1984 Corvette: Service Bulletin: Side Door Lateral Movement

Source: Chevrolet Dealer Service Bulletin

Bulletin No: 84-118, Section: 10 (I)

FIGURE 1

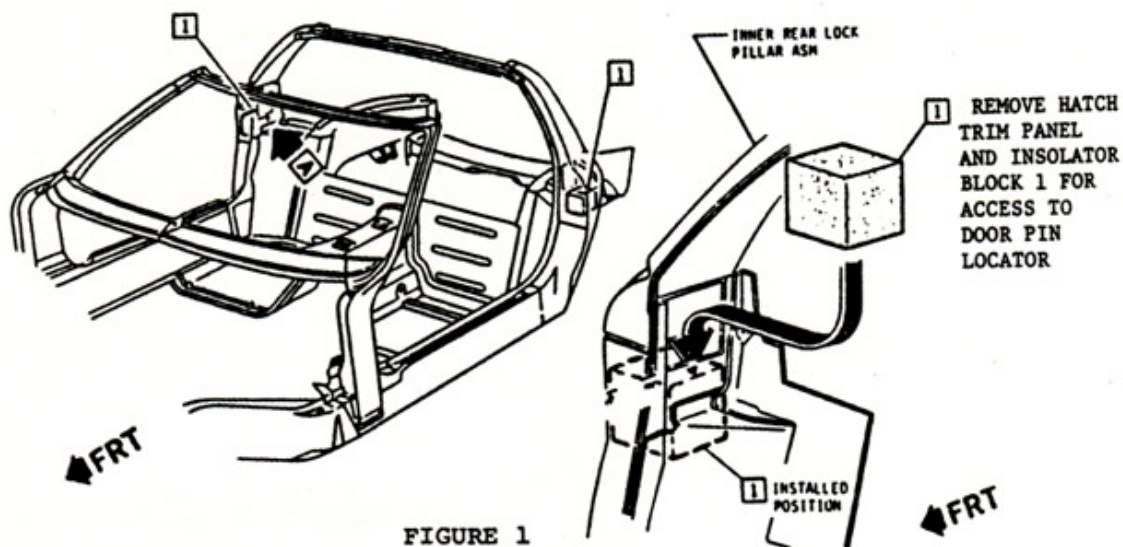
Early built vehicles have 35mm (1 3/8") long door pin assemblies. If the vehicles is equipped with 35mm (1 3/8") long pins, it will be necessary to install pin assembly, P/N 14060282, which is a shorter design (25mm (1") long.)

Verify the plastic sleeve is installed in the pin locator assembly. With the vehicle door closed, loosen the locator three (3) attaching bolts (see Figure 1). The locator assembly is to be centered fore-aft and vertically on the door pin. Push the locator outboard to fully engage the door pin and tighten the locator attaching bolts to 11 N.m (8 ft. lbs.)

FIGURE 2

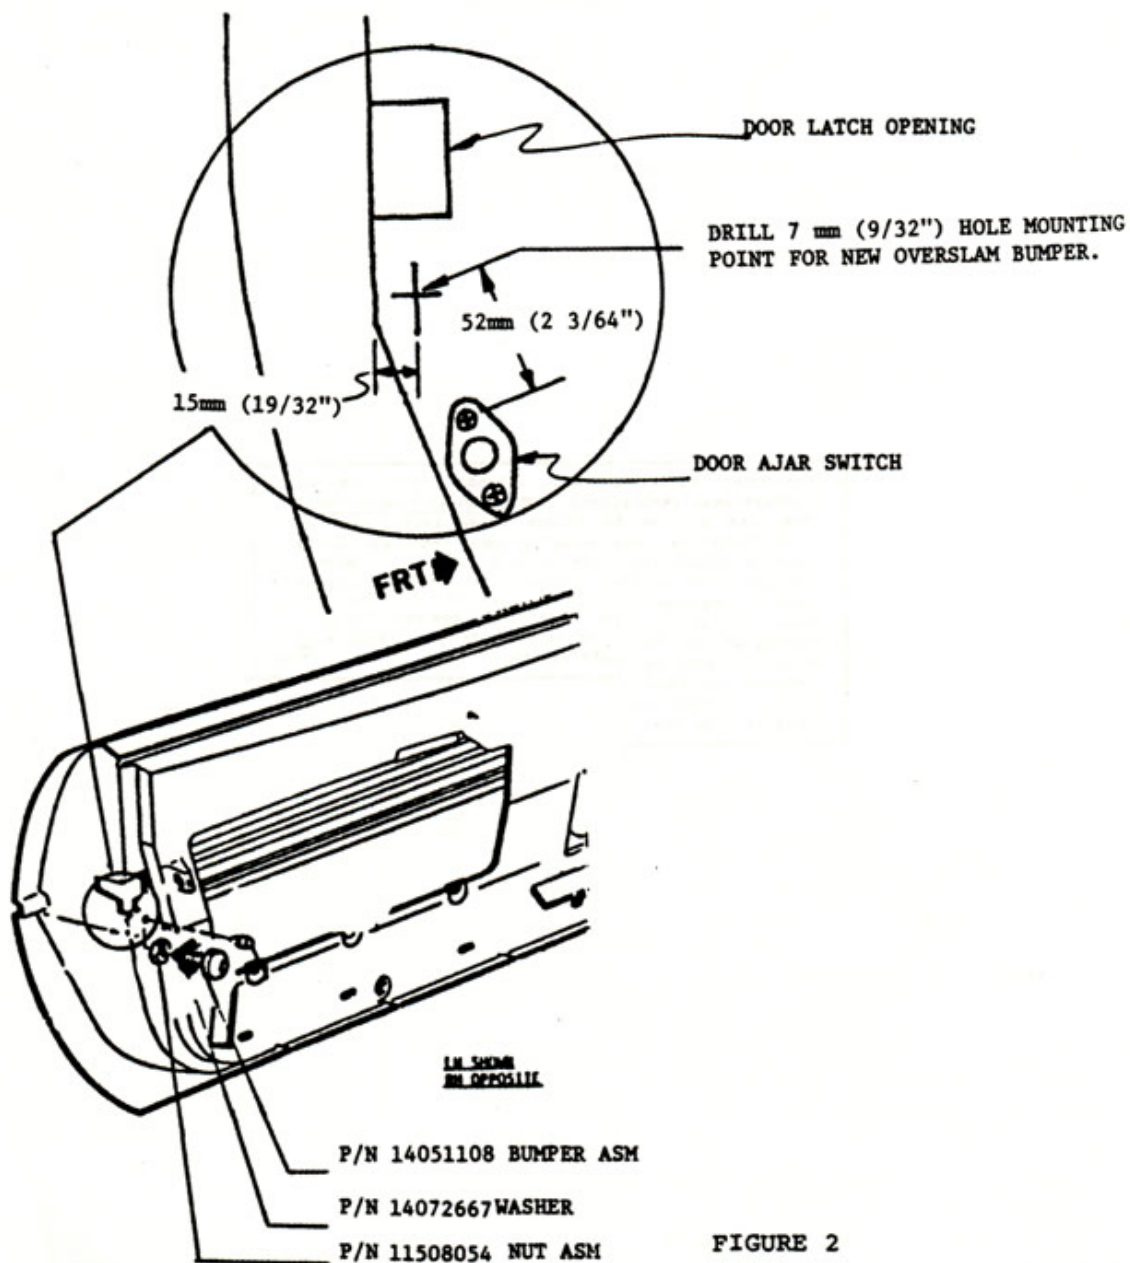
Some early built vehicles did not have overslam bumpers. if this is the case, it will be necessary to drill a 7mm (9/32") hole in the door (see Figure 2).

Replace the discarded production bumper(s) with bumper, P/N 14051108, attaching nut, P/N 11508276, and P/N 14072667, flat washers, which are to be used as bumper shims. The number of shims required will vary from vehicle to vehicle depending on "Build stacks".

Add shims (washers) between bumper and door, as required, to eliminate lateral door movement (see Figure 2). DO NOT "OVERSHIM" BUMPER.

Once shim pack has been established, tighten bumper retaining nut to 12 N.m (9 ft. lbs.) and check the door ajar lamp for proper operation. The door ajar switch is self-adjusting and cannot be reset.
